What's wrong with the revised hydro schemes in Glen Etive – the Allt Mheuran

The revised Allt a Mheuran Scheme

The current bridge to Coileitir is narrow and blends in quite well to the surroundings – the new bridge on the left

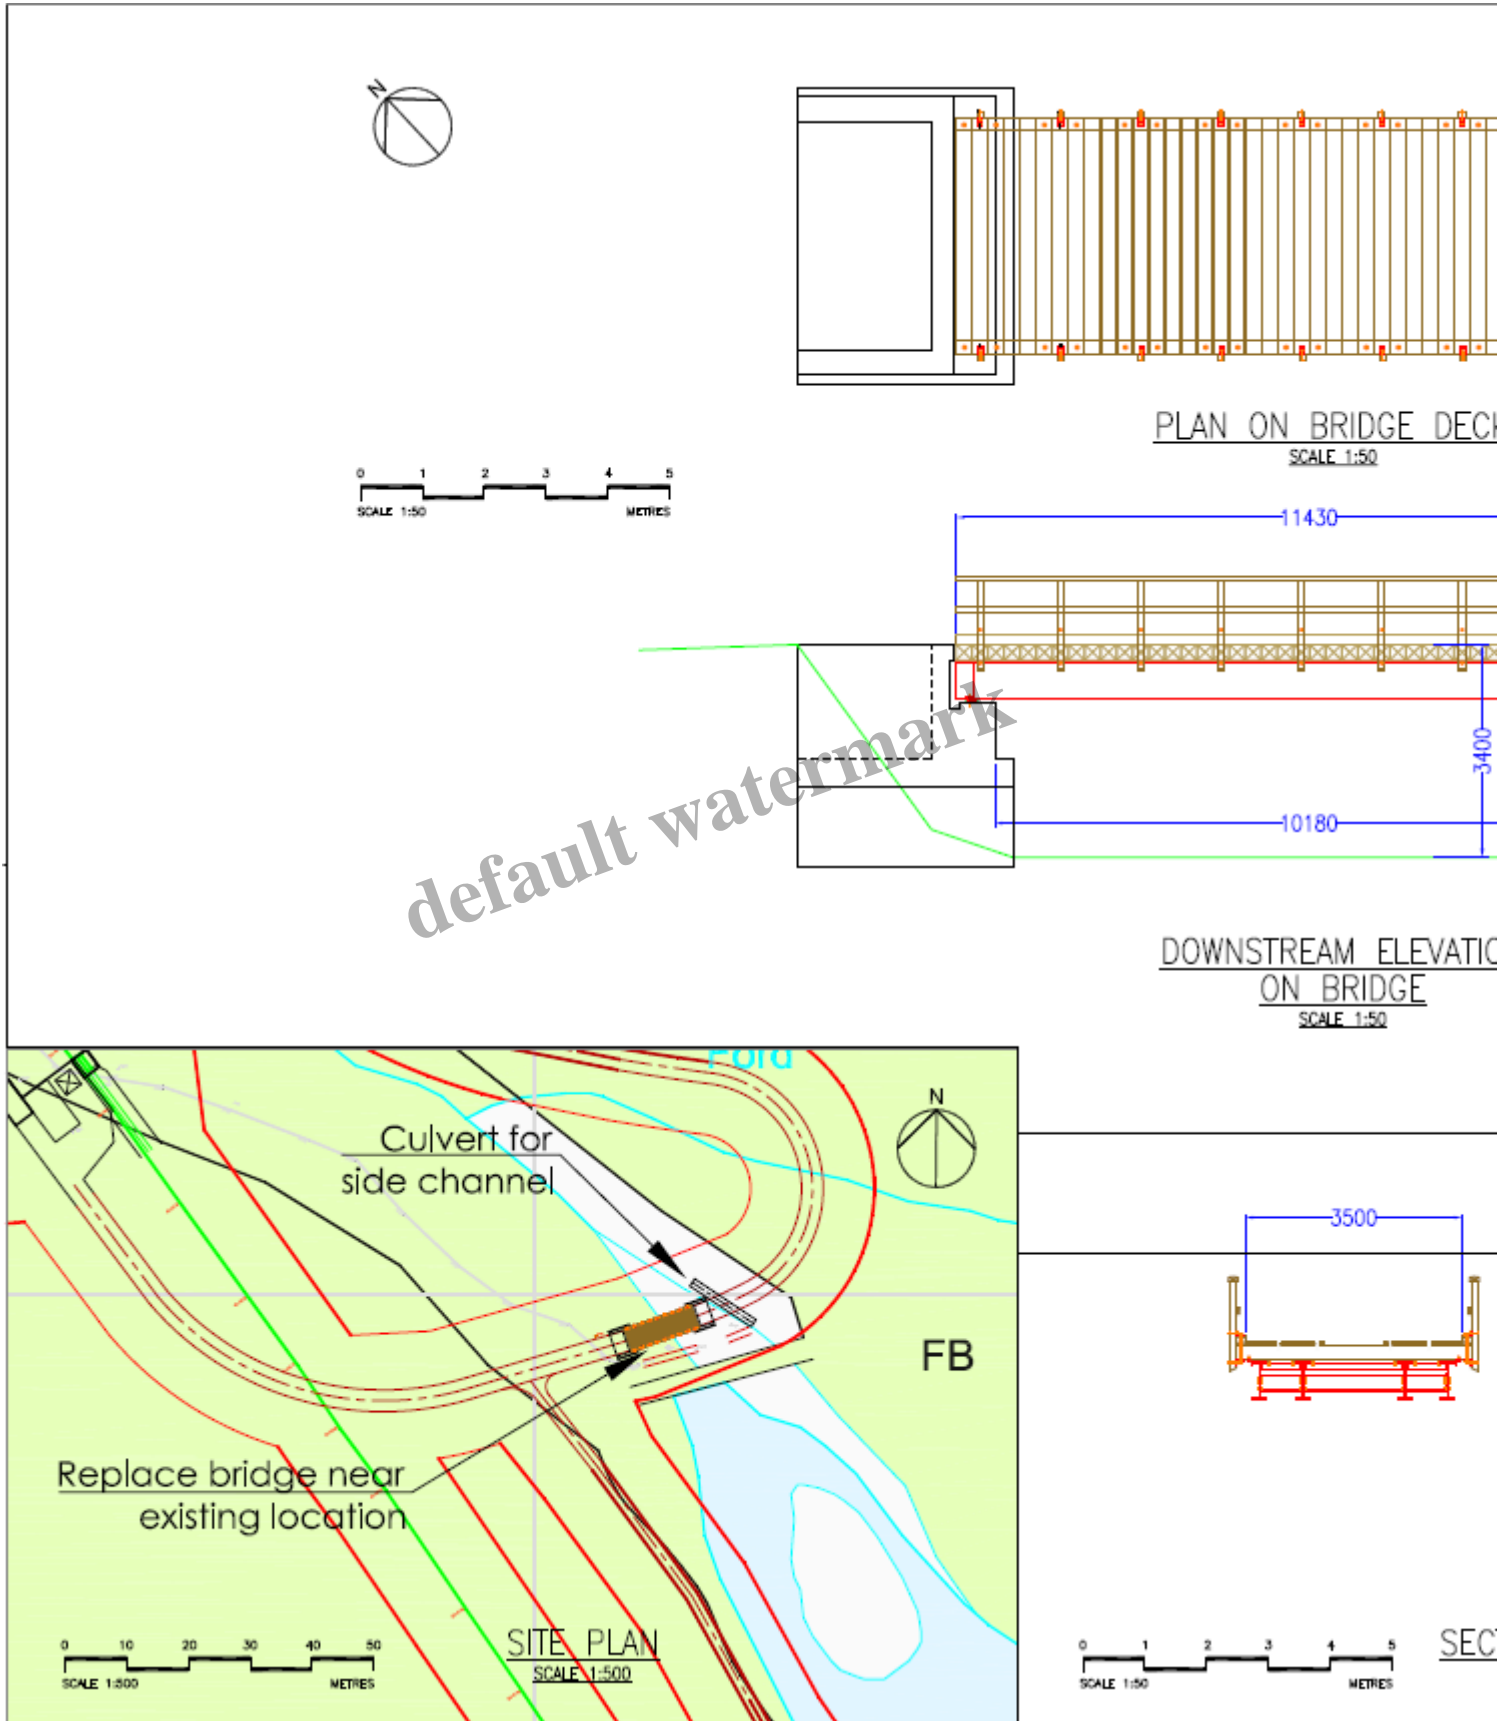
The proposal is to build a new bridge at Coileitir on the north side of the existing bridge. Following objections from SEPA, the revised plans now state the old bridge will be demolished and totally removed from the site. I can find nothing in the plans to say how many trees would need to be felled,

how the new bridge abutments would be constructed, their appearance (concrete?) or how the design of the bridge will fit the surroundings:

That is not acceptable for a significant new structure in a National Scenic Area.

Looking down the Allt Mheuran from the foot bridge. A permanent new road is proposed to follow either side of the river downstream from here.

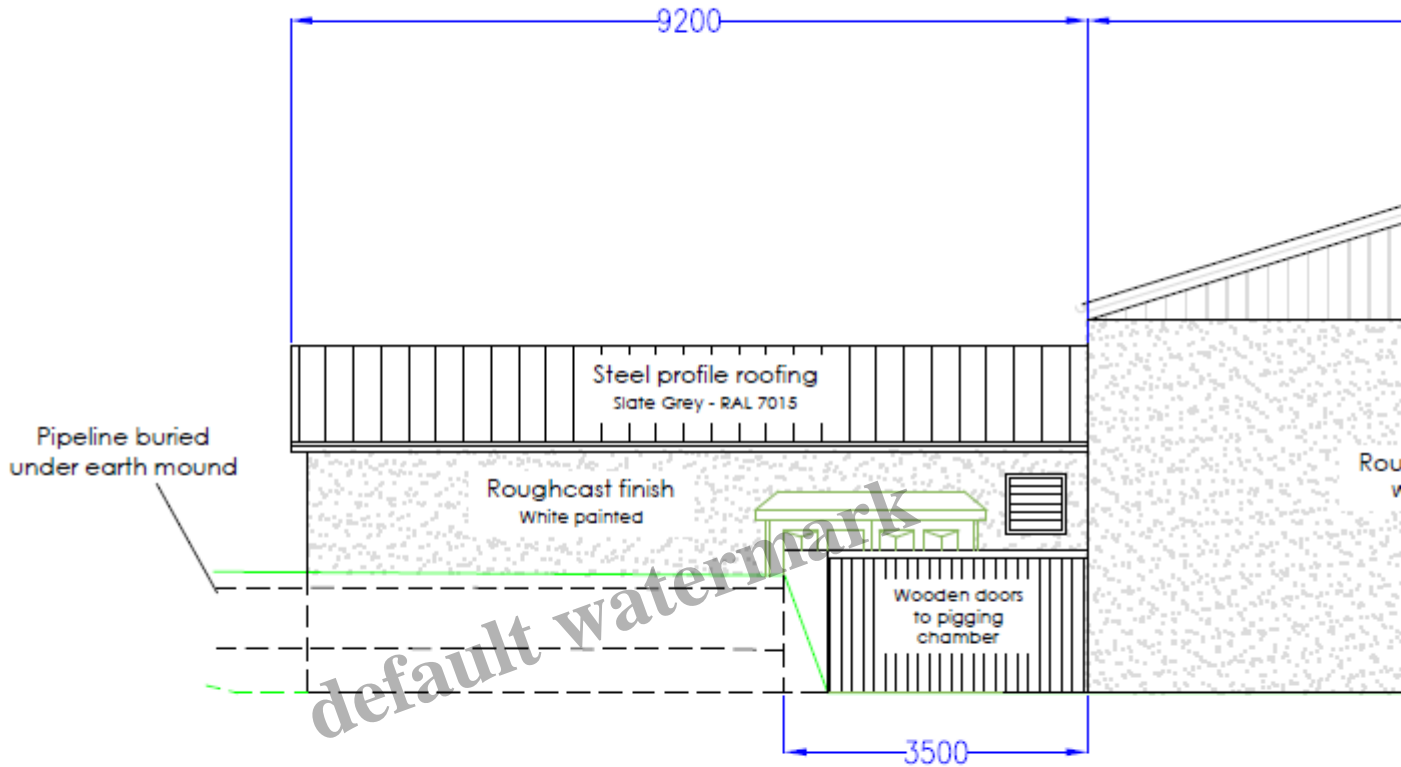
Dickins Hydro have almost completely failed to assess the impact of the proposed new road on the landscape or the recreational experience, including the impact on Wild Land. (The zones of Theoretical Visibility Assessments have not been revised to take account of the change in plan or past deficiencies). This in itself should be sufficient for Highland Council to reject the application.

Fig 3. Penstock excavation process for working within half of the 20m corridor

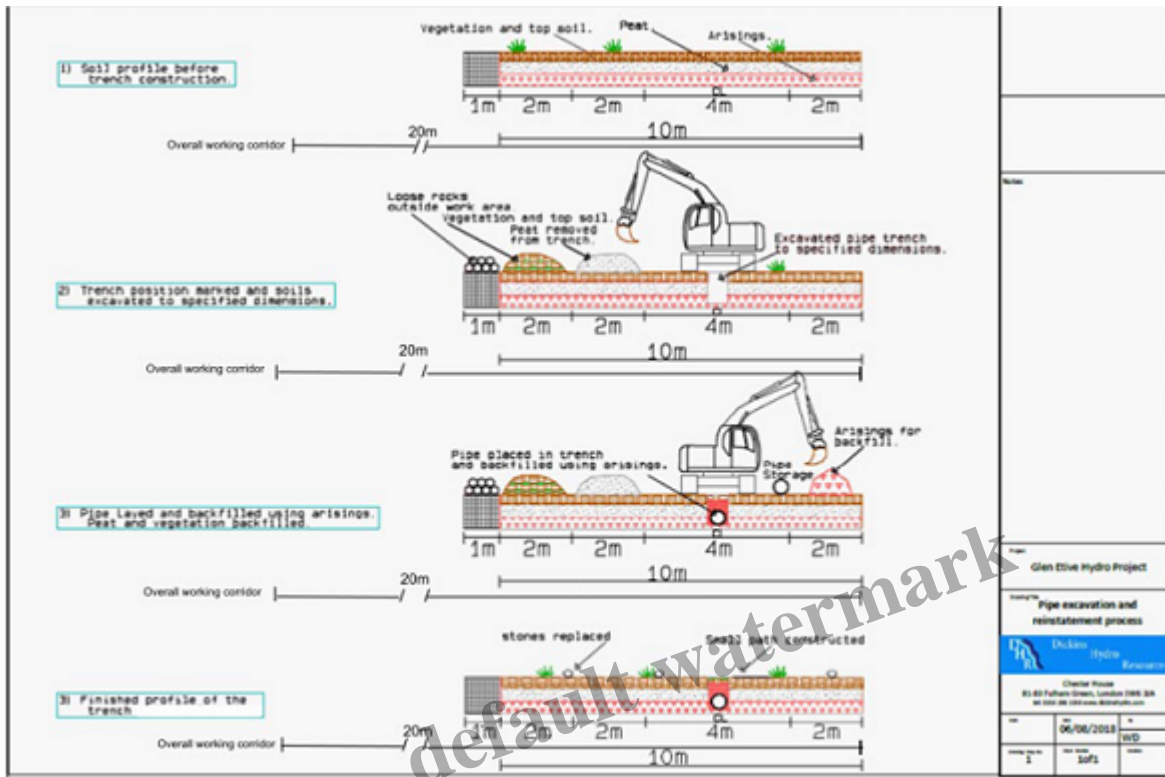
Dickins Hydro will NEVER be able to bury the pipeline here in the way described on this type of terrain.

Whatever route the pipeline takes will require boulder fields to be shifted. The Planning Applications mentions scattering boulders on top of whatever surface they create. Restoring the boulder formations properly would require every single boulder to be marked and replaced by hand. . Unless that is required by Highland Council – and it would be phenomenally expensive – constructing a pipeline here will leave a permanent mark on what is a very special landscape.

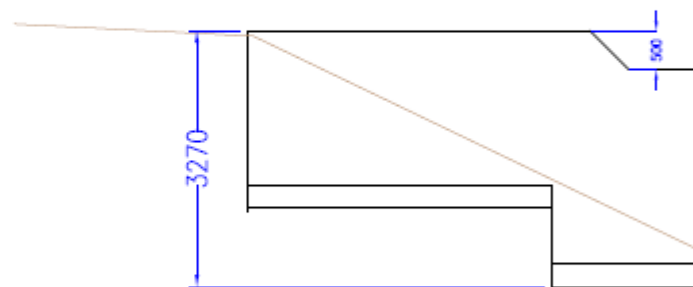
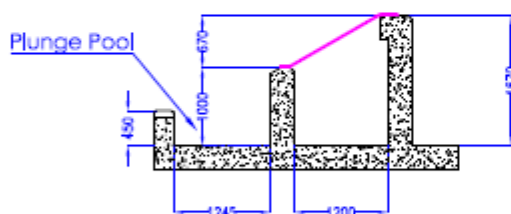
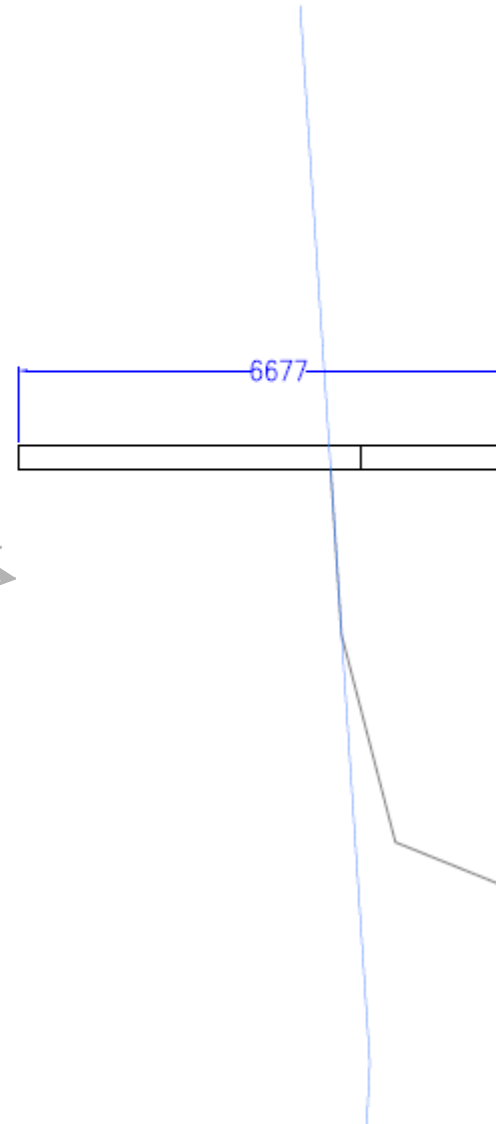
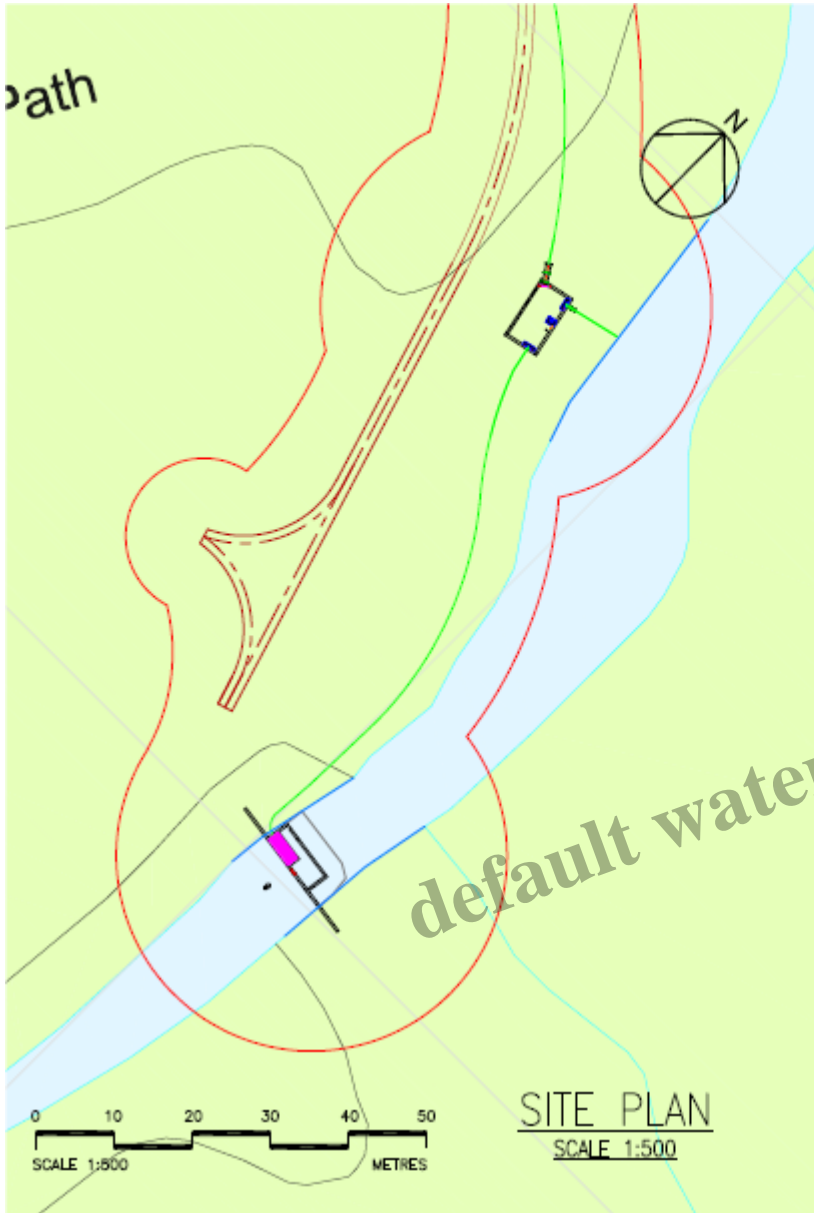
This is either a deliberate attempt to mislead or wishful thinking based on a failure to look at the terrain properly. Highland Council should not accept this but instead demand detailed plans showing exactly where the track will go and how Dickins Hydro's specialist re-instatement team propose to restore the ground before the application goes any further.
